# UNITED STATES PATENT AND TRADEMARK OFFICE

10/523,504

<b>Office Action Summary</b>	<b>Application No.</b>	<b>Applicant(s)</b>	
	10/523,504	UNGEMACH ET AL.	
	<b>Examiner</b>	<b>Art Unit</b>	
	Kari Petrik	3743

### DETAILED ACTION

**FIG. 1A**

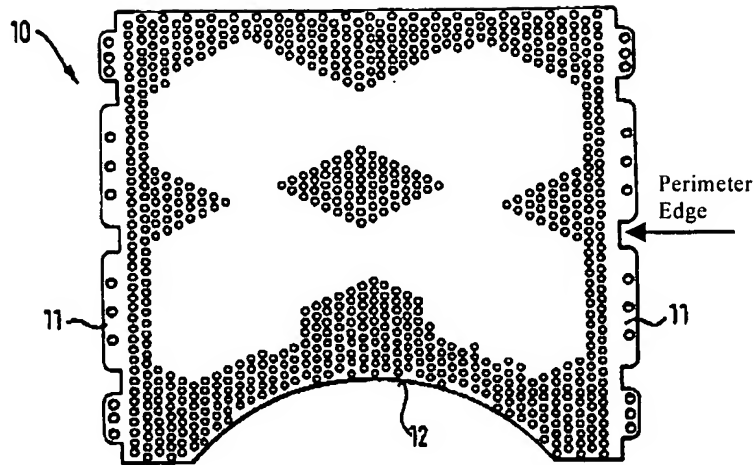
6. Regarding claims 1 and 10, Vilsmeier et al disclose a patient restraint member comprising an integral, one-piece sheet of thermoplastic material (10) having spaced apart groups of perforations and solid bands extending between the groups of

perforations and extending at least partially across the sheet (Figure 1A). The sheet has a perimeter edge (see Figure below) lying in a common plane and is free of additional strips of material (sheet 10 itself is free of additional strips and is capable of being used alone to restrain the user). Vilsmeier et al discloses a generally planar frame (31) arranged to be attached to and extending around a portion of the perimeter edge of the sheet and being coplanar with the perimeter edge. Vilsmeier does not disclose that the frame is U-shaped.

7. Regarding claims 2-8 and 11-16, Vilsmeier et al discloses a thermoplastic sheet (10) having groups of perforations and solid bands extending across the sheet between the groups of perforations to provide rigidity (Figure 1A). The solid bands criss-cross the sheet and intersect at a location spaced inwardly from the edge. Vilsmeier et al also discloses a thermoplastic sheet having a non-perforated edge (the arrow in Figure 1A below is considered a non-perforated edge). Vilsmeier et al do not disclose that the solid bands extend completely across the sheet, and do not disclose that they extend in a perpendicular or non-perpendicular angle from the perimeter edge.

However, a thorough reading of the specification provides no criticality to the arrangement of the bands. Specifically, Applicant has not disclosed that having bands that extend from the perimeter edge at a perpendicular angle or non-perpendicular angle provides an advantage over bands extending through the sheet at any other angle.

At the time the invention was made, it would have been an obvious matter of design choice to one of ordinary skill in the art to have made the thermoplastic sheet with the various solid band configurations, because Applicant has not disclosed that such configurations provide an advantage, are used for a particular purpose, or solve a stated problem. One of ordinary skill in the art, furthermore, would have expected Vilsmeier et al.'s thermoplastic sheet and Applicant's invention to perform equally well with either the solid bands used by Vilsmeier et al, or the various claimed designs of solid bands and perforations because both configurations would perform the same function of providing rigidity.

9. The Applicant argues that the Examiner's interpretation of Figure 1A is incorrect in that the non-perforated areas shown are merely a drawing convention so that the draftsman need not draw the holes across the entire area of the sheet. The Examiner spoke with Joshua Chase at the USPTO Drafting Review Branch who stated that this is not a drawing convention, and that the figure does show a sheet having a perforated area and a non-perforated area.

10. The examiner directs the Applicant to MPEP § 2125. Specifically, “When the reference is a utility patent, it does not matter that the feature shown is unintended or unexplained in the specification. The drawing must be evaluated for what they reasonably disclose and suggest to one of ordinary skill in the art”. Even though the non-perforated area is not described in the specification, the figure clearly shows the sheet having a perforated area and a solid non-perforated area, and therefore, it can be used as prior art.
